**CERTIFICATE OF APPROPRIATENESS**

**Property:** 1507 Ashland Street, Lots 15 & 16, Block 146, Houston Heights Subdivision. The property includes a historic 1,380 square foot, one-story wood frame single-family residence situated on a 8,800 square foot (66' x 132') interior lot.

**Proposal:** Alteration – The applicant received a COA at the January 2015 HAHC meeting to construct a 1½ story addition to the existing one-story residence. The applicant has revised the approved addition and now request approval for a rear one-story addition.

**NORTH SIDE ELEVATION**

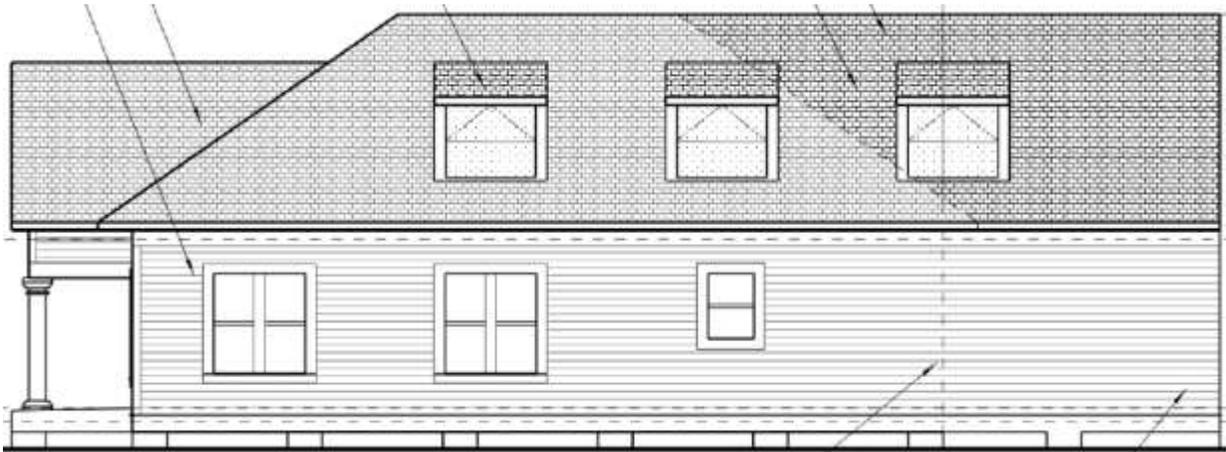
**Windows/Doors:** The residence features a wood front door and wood 1-over-1 sash windows; the front entry door and all sash windows will be retained. The addition will feature wood 1-over-1 sash and single lite casement and fixed windows. *(Previously approved the addition will feature aluminum fixed and casement windows).* A 1-over-1 sash window will be installed at the rear corner of the residence on the north elevation.

**Side Elevation:** Please see elevation drawings on pg. 8  
(North)

**WEST (REAR) ELEVATION**

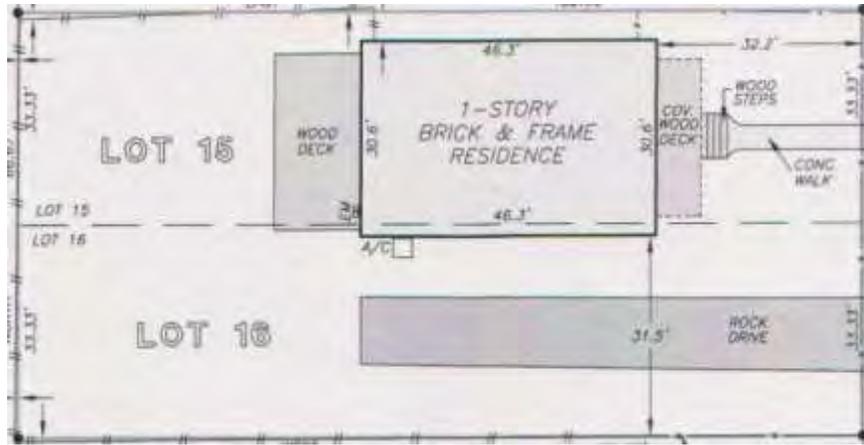
**Rear Elevation:** Please see elevation drawings on pg. 10  
(West)

**SITE PLAN**

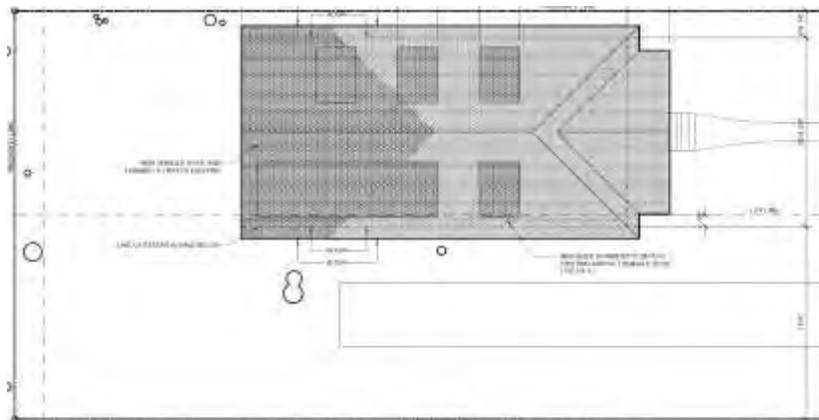
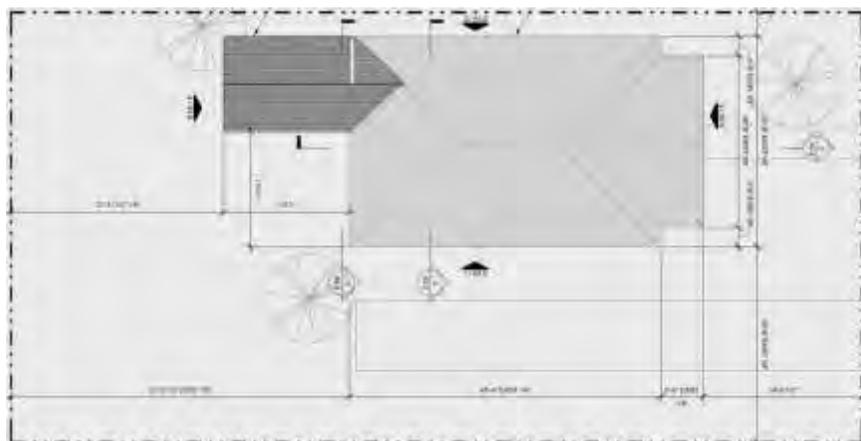
**Setbacks:** The residence is setback 31'-3" from the front property line, 3'-8" from the side, north property line, 30'-4" from the side, south property line, and 52'-6" from the rear property line; all setbacks will remain unchanged. The addition will be setback 3'-8" from the side, north property line, 48'-3" from the side, south property line, and 33' from the rear property line.

**ROOF PLAN**

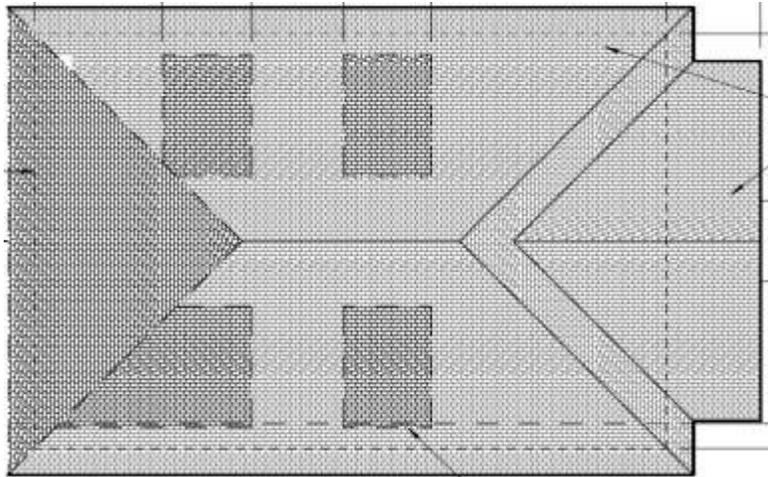
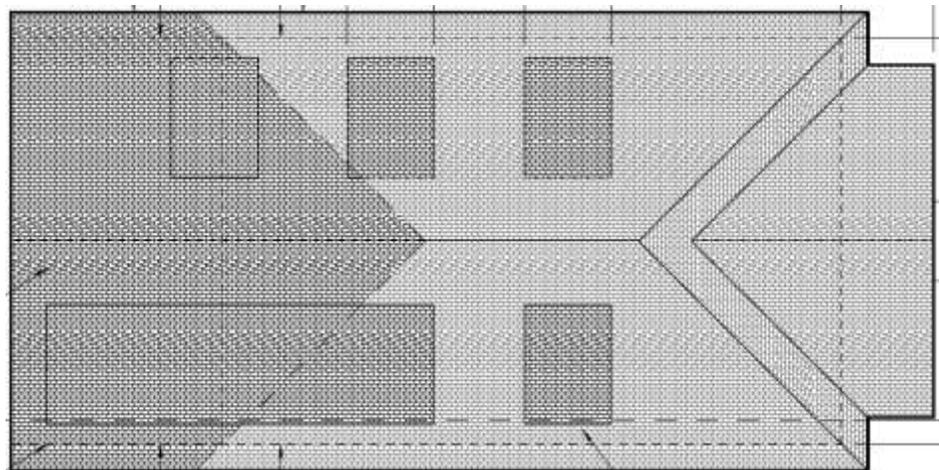
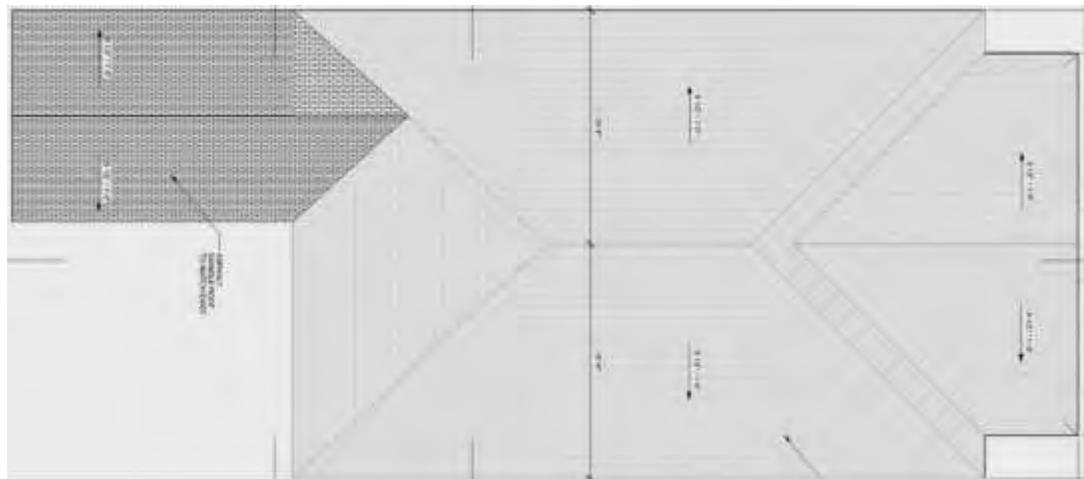
**Roof:** The residence features a hipped roof with a 6/12 pitch clad in composition shingles. The addition will feature a gable roof with a 6/12 pitch and will be clad with composite shingles. *(Previously approved the addition will extend the roof rearward with a rear gable and feature a 6/12 pitch and be clad in composition shingles).*
